Summary of Questions and Answers Exchanged During and Since the Workshop of June 29, 2016, for Replacement of Meadow Way Bridge

Meadow Way Bridge Replacement
Frequently Asked Questions

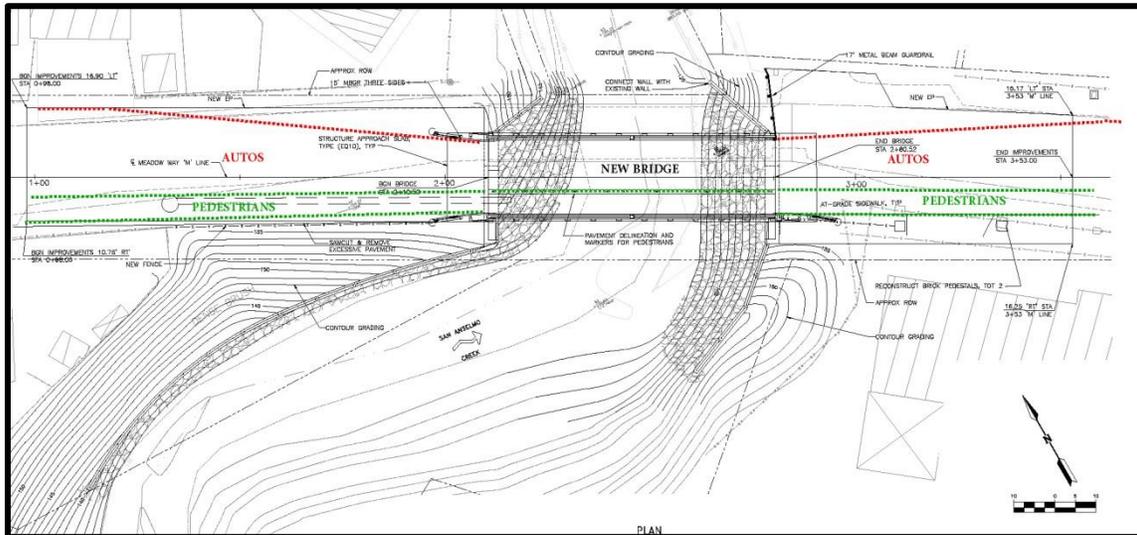
Q4: Can the replacement bridge have only a single lane?

A4: Caltrans has agreed to a single-lane bridge as long as its width, curb-to-curb, is a minimum of 18'. This bridge will also need another 3.5 feet for barrier railings, making it a total of 21.5 feet wide edge-to-edge. The existing bridge is 14 feet wide. Please see below for details of the width of the new bridge.

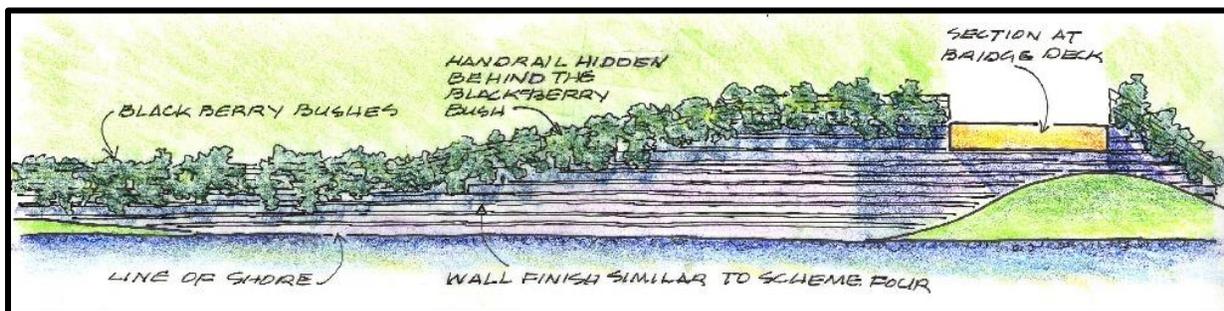
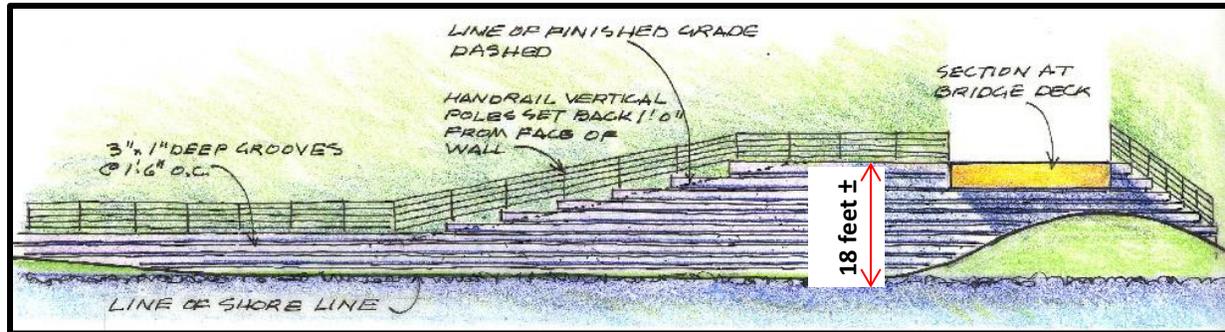
Q12: What wall types have been considered?

At the latest meeting, some residents expressed concern regarding the size and height of the retaining wall. Since then, a new wall top that follows the finished slope behind it with short steps (8"-10" high) has been developed as well. This will help to visually give the impression of a shorter wall. This additional wall option will be in the survey to be sent to the residents to mark their wall choices. Please see below for the two additional concept drawings for the wall.

A12: Two types of walls, a conventional concrete wall and a mechanically stabilized embankment (MSE) wall, each with three different surface finishes, including a living green surface, have been considered. The non-green walls would receive surface architectural treatment for aesthetics. Each of these wall alternates may have a stepping top with 2'-3' high steps as the wall height diminishes from the bridge toward the wall's end. Renderings and examples of the two wall types were presented at the meeting and are available on the Town website in the Bridge Type Selection Report.
